# 100 Mount Street North Sydney

Project Approval MP08\_0241

Environmental Assessment Report – Modification5

June 2016

FIGURE 11 – LOWER GROUND FLOOR LEVEL AMENDMENTS

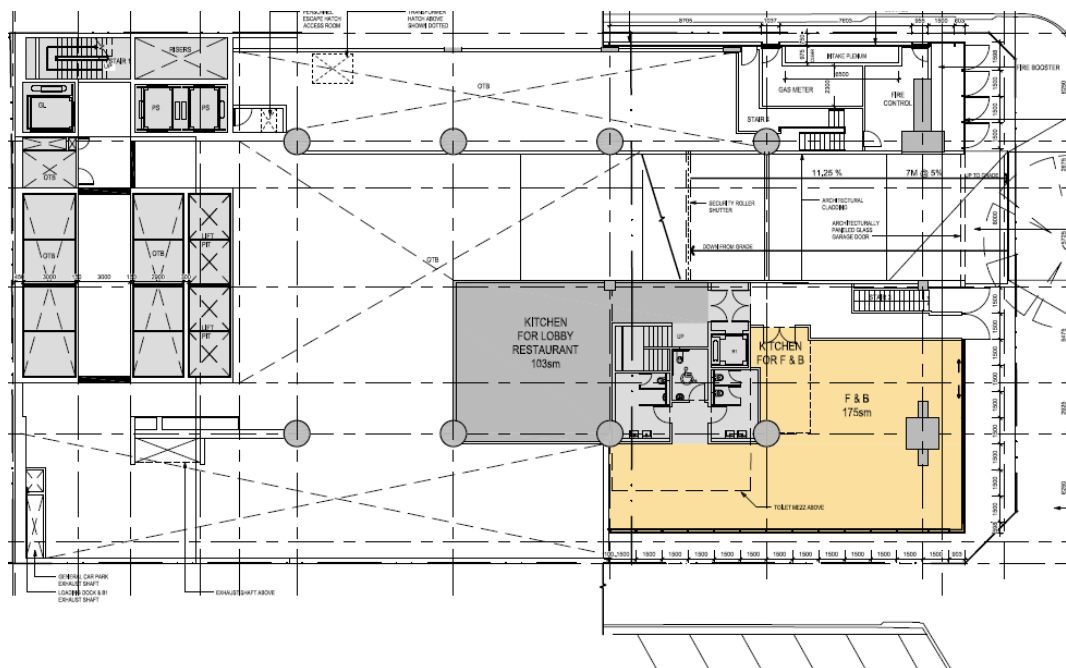
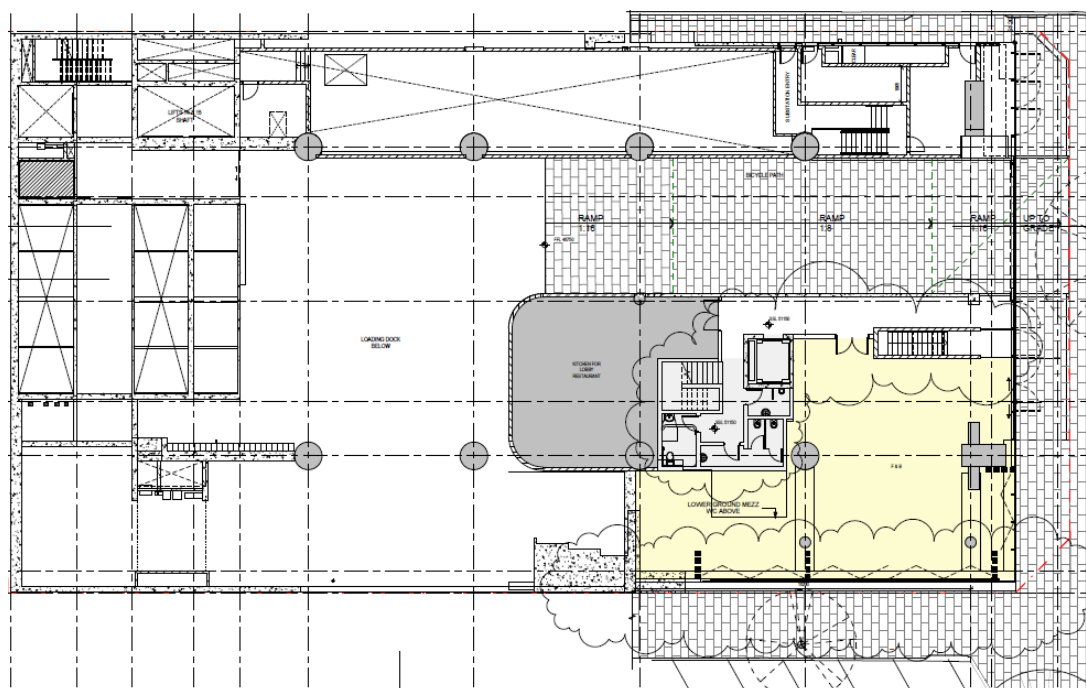
The lower ground floor level modifications include:

- Extension of food and beverage tenancy to the Mount Street boundary.
- Relocation of fire stair location from Level B1.
- Reconfiguration of lobby restaurant kitchen and bathrooms.

FIGURE 12 – LOWER GROUND FLOOR MEZZANINE AMENDMENTS

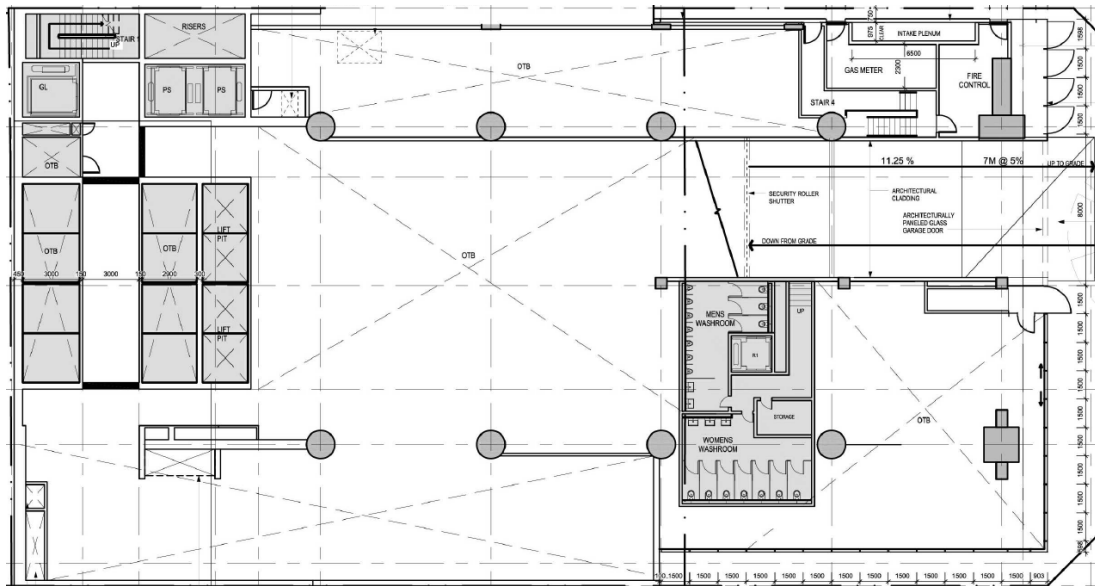
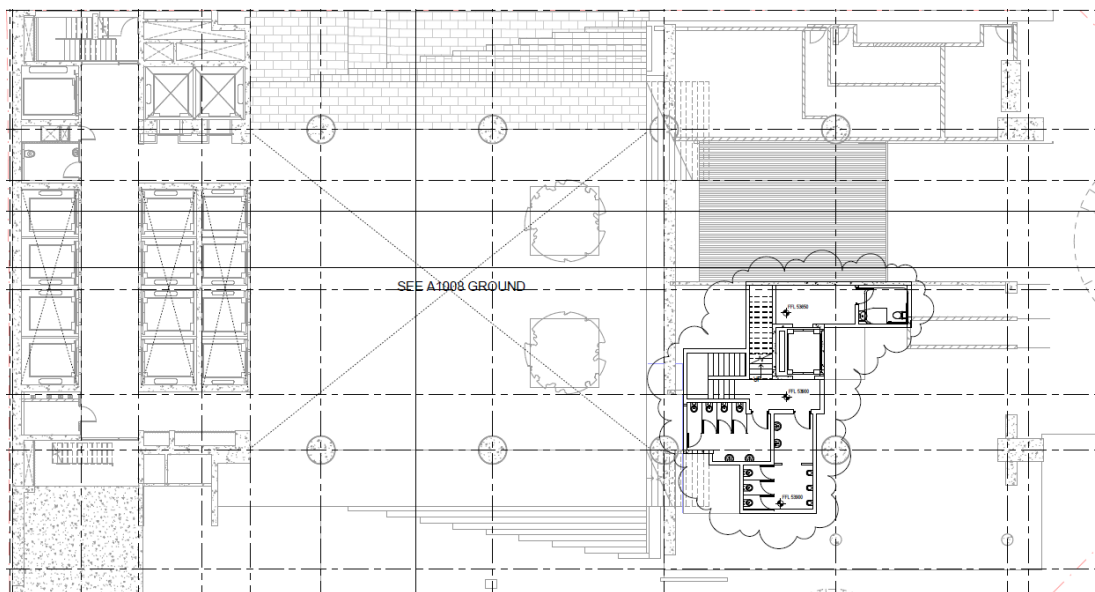
The lower ground floor mezzanine modifications include:

- Reconfiguration of bathrooms and addition of disabled toilet.

FIGURE 13 –GROUND FLOOR LEVEL AMENDMENTS

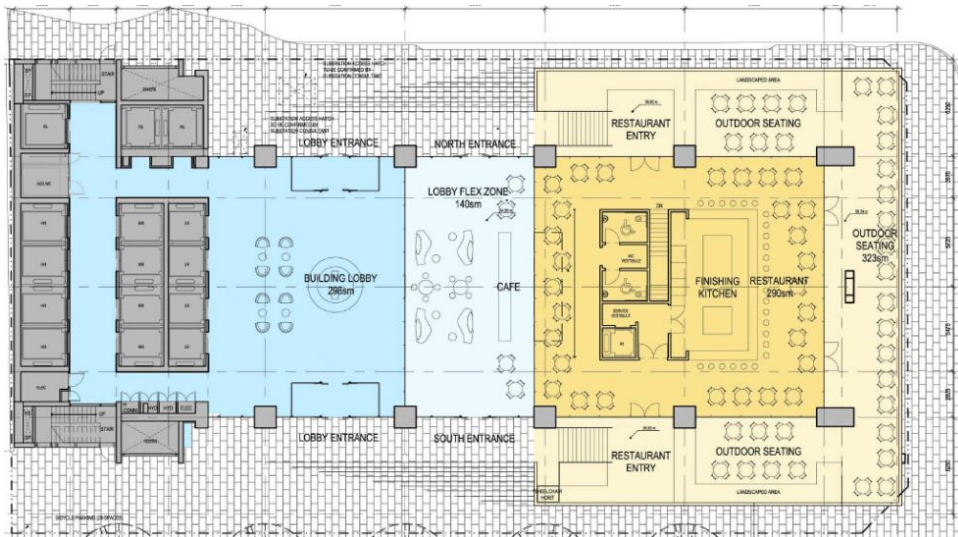
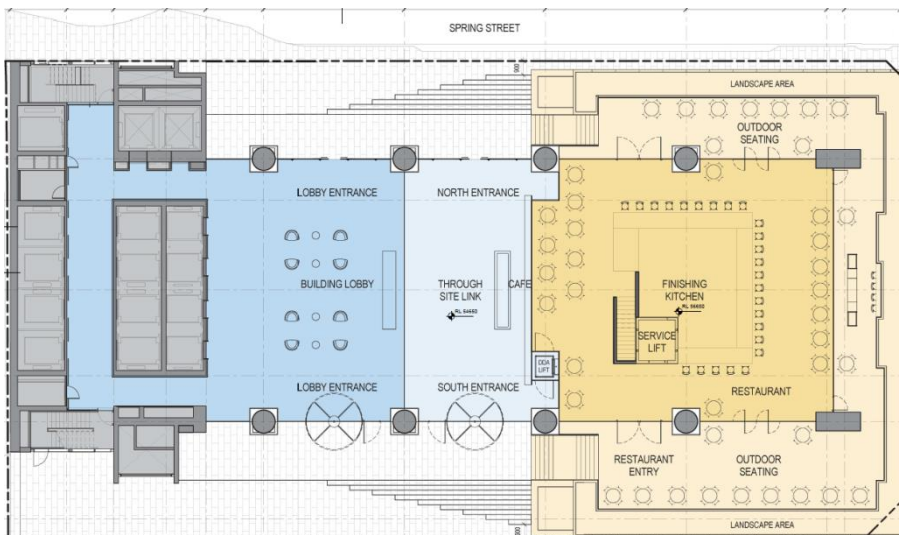
The ground floor level will be amended as follows:

- Replacement of the sliding lobby doors at the southern Mount Street entry to revolving doors and an extension to the landing to accommodate.
- Extension of outdoor seating and landscape area to Mount Street boundary.
- Deletion of restaurant disabled bathroom which is relocated to the lower ground floor mezzanine.
- Reconfiguration of restaurant finishing kitchen.

FIGURE 14 – GROUND FLOOR MEZZANINE AMENDMENTS

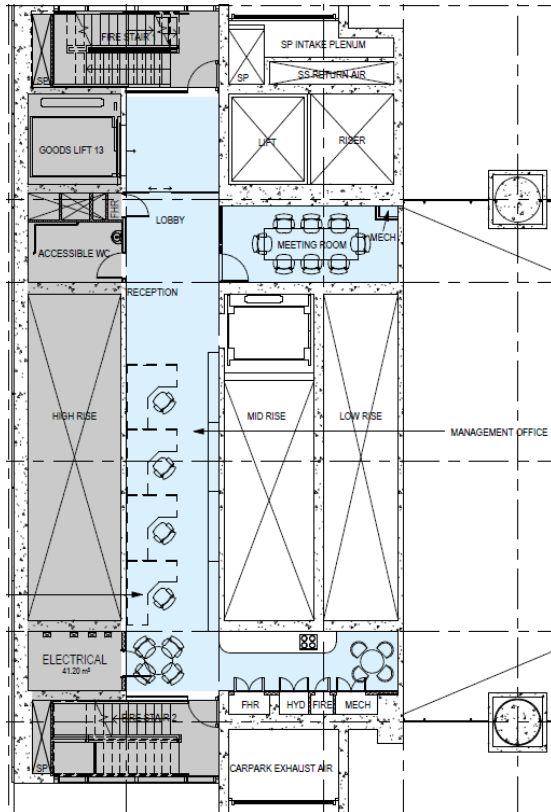
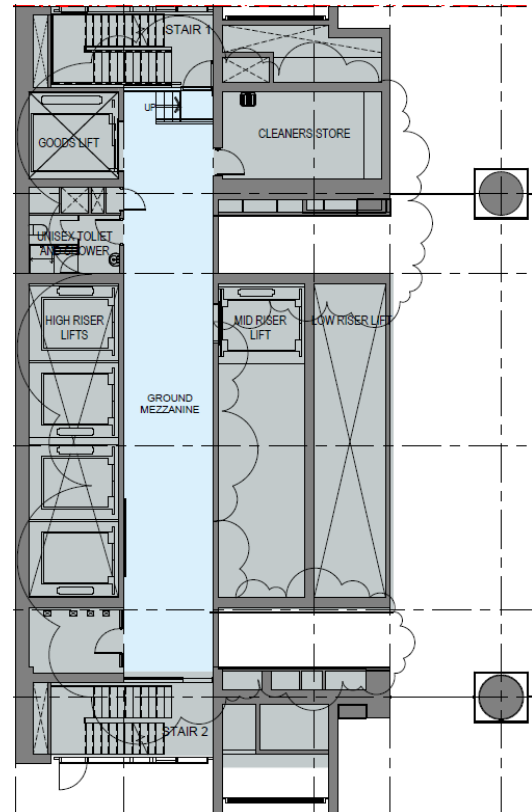
The ground floor mezzanine level will be amended as follows:

- Deletion of management office and meeting room, with use of area as a corridor.
- Creation of cleaners storeroom in lieu of lift core.

FIGURE 15 –LEVEL 1 AMENDMENTS

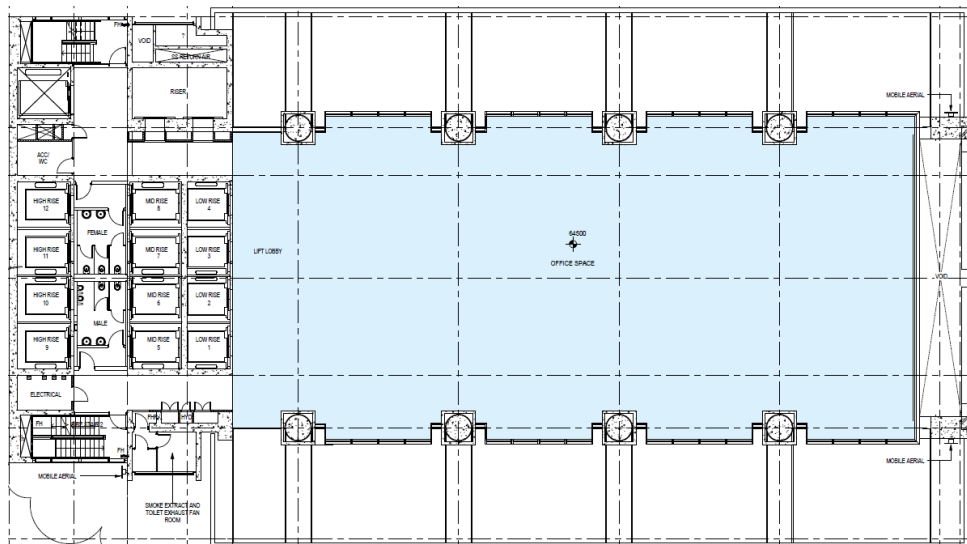
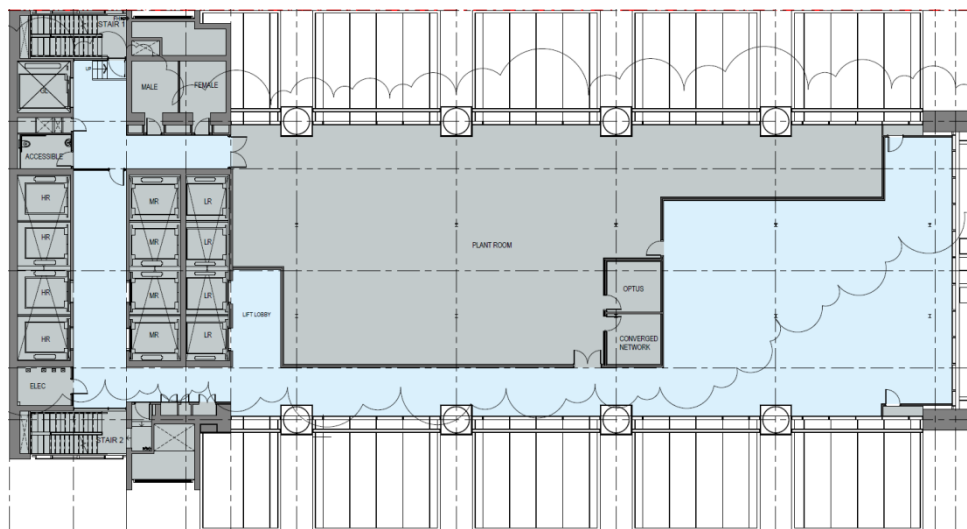
The following modifications are proposed for Level 1:

- Creation of plant room, with Optus and converged network rooms internally, where previously located on the Level 1 Mezzanine.
- Reduction and reconfiguration of office space.
- Creation of two toilets in lieu of lift core.

FIGURE 16 –LEVEL 1 MEZZANINE AMENDMENTS

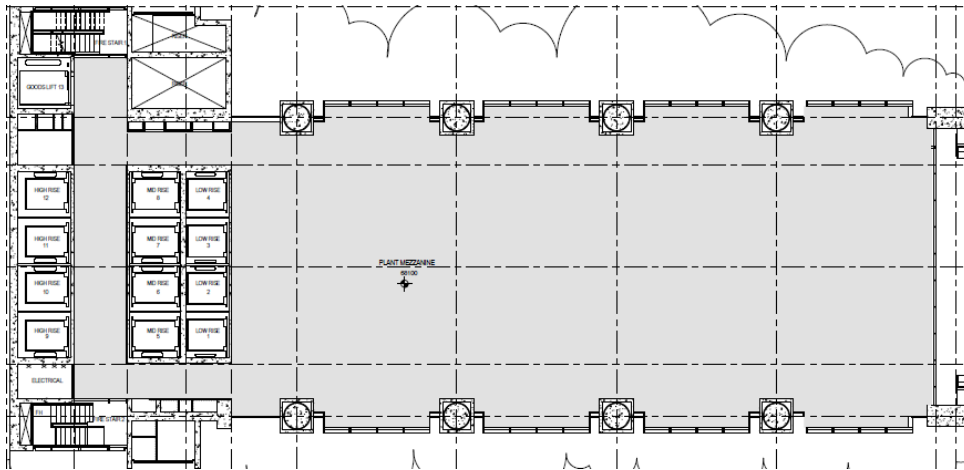
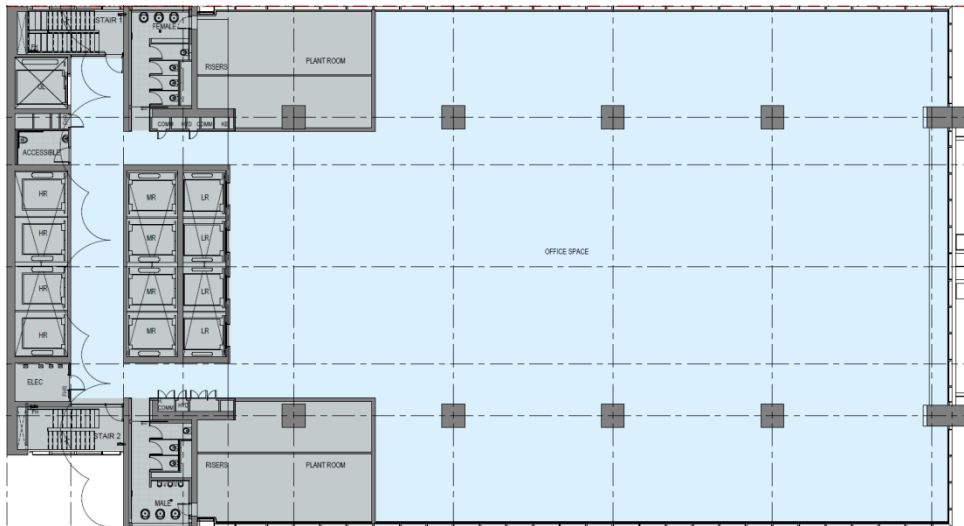
The following modifications are proposed for Level 1 Mezzanine:

- Extension of floor to northern and southern boundaries to form full floor/level.
- Re-numbering of floor from Level 1 Mezzanine to Level 2, with subsequent changes to floor numbers above.
- Reduction in plant equipment space and change of use to office floor, with plant equipment being relocated to Level 1.
- Creation of male and female toilets.
